# Access Compliance Report

## Public Rights-of-Way

### (Curb Ramps)

Intersection ID: N/A	Main Street: E_W_T_HARRIS_BV	Cross Street: N/A	Location: NE
ADA ID: CB53B134AF14	Ramp Type: PerpDiag	Initial Pass/Fail: Fail	Overall Compliance: No
Severity Score: 12.5			
Codes/Mitigation Info/Possible Solution		Field Measurements/Component Compliance

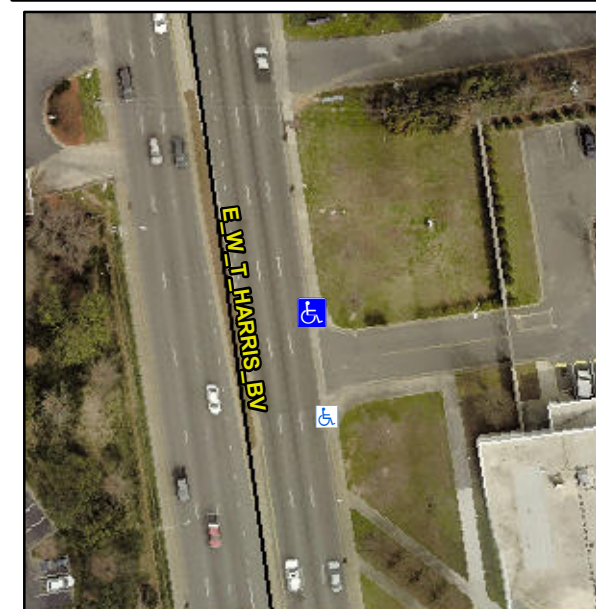
**R304.2.2**

Compliance	Description	Data	Compliance	Description	Data
N/A	Ramp Length (in)	60.0	No	Ramp Slope (%)	11.4
Yes	Ramp Width (in)	50.0	Yes	Ramp XSlope (%)	1.8
N/A	Flare Type LT	N/A	N/A	Flare Type RT	N/A
N/A	Flare Slope LT (%)	N/A	N/A	Flare Slope RT (%)	N/A
N/A	Flare Traversable LT?	N/A	N/A	Flare Traversable RT?	N/A
N/A	Landing Length (in)	N/A	N/A	DWS Provided?	N/A
N/A	Landing Width (in)	N/A	N/A	DWS Contrast?	N/A
N/A	Landing Slope (%)	N/A	N/A	DWS Length (in)	N/A
N/A	Landing X Slope (%)	N/A	N/A	DWS Full Width?	N/A
N/A	Landing Curb? (Y/N)	N/A	N/A	DWS Offset (in)	N/A
N/A	Shared Landing?	N/A			
N/A	Gutter Ponding?	N/A	N/A	Gutter Slope (%)	N/A
N/A	Gutter Lip Ht (in)	N/A	N/A	Gutter X Slope (%)	N/A
N/A	Painted X Walk1?	No	N/A	Painted X Walk2?	No
	X Walk 1 Direction	To W		X Walk 2 Direction	To S
N/A	X Walk 1 Width (in)	N/A	N/A	X Walk 2 Width (in)	N/A
	X Walk 1 Slope (%)	1.7		X Walk 2 Slope (%)	0.7
	X Walk 1 X Slope (%)	1.1		X Walk 2 X Slope (%)	0.7

**Remove & Replace Curb Ramp With Two New Directional Ramps or Equivalent.**
